## **REMARKS**

Application Serial No. 10/691,678  
Amendment Dated 09 December 2004  
Reply to Office Action of 14 September 2004  
Replacement Drawing Sheet

FIG.1

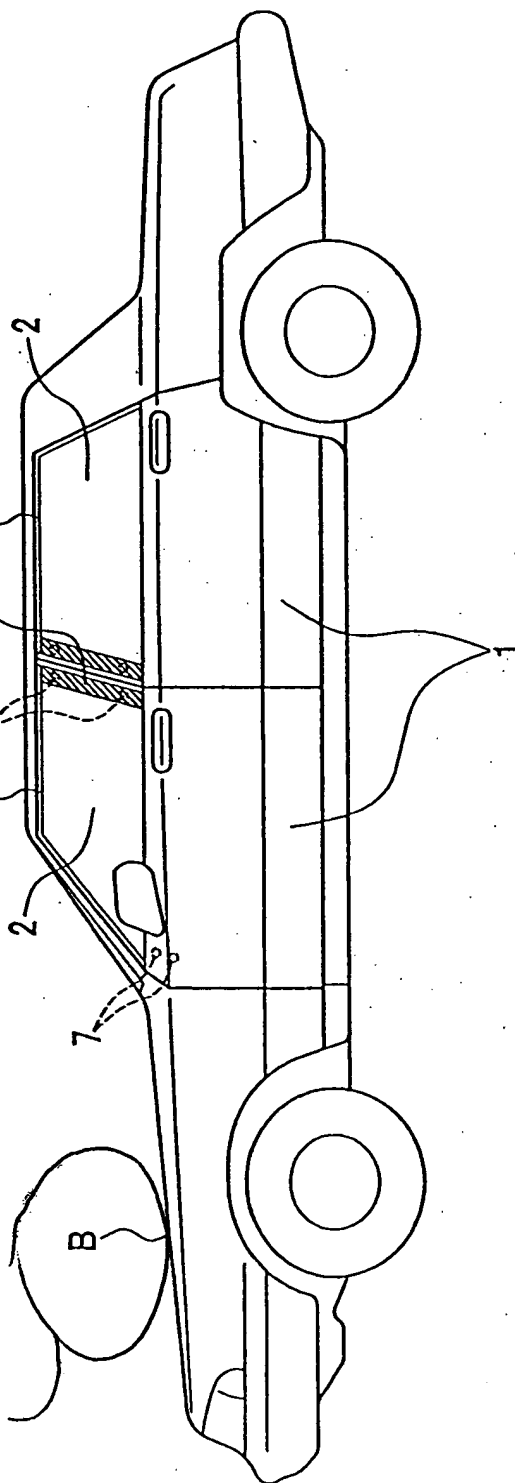
Please amend Figures 1 and 6 of the drawings, according to the attached replacement sheets for Figures 1 and 6. In Figure 1, the reference character B and its associated lead line have been deleted, pursuant to the suggestion of the Examiner. In Figure 6, the words "PRIOR ART" have been added to more clearly indicate that the subject matter of the Figure is prior art included for discussion purposes.

*Ref. character  
and lead line removed*

FIG. 6

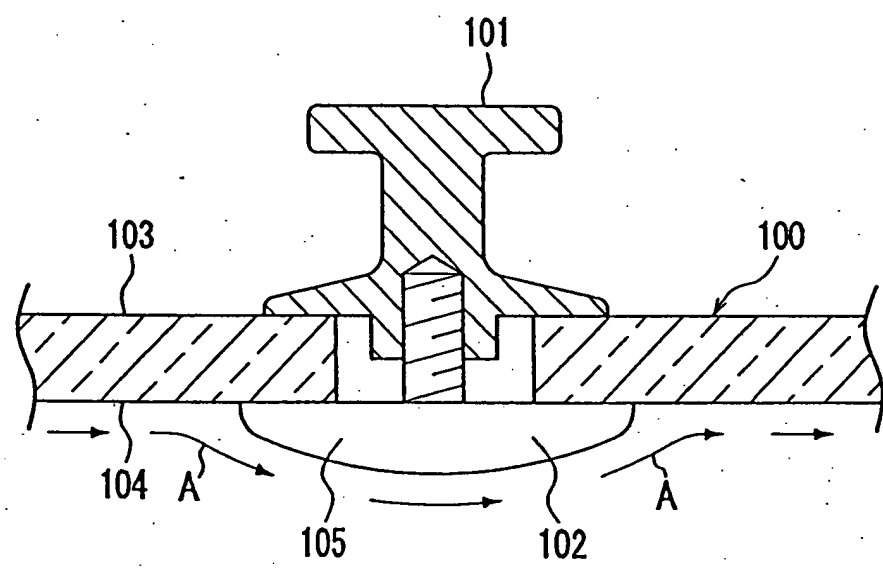
Words have been added
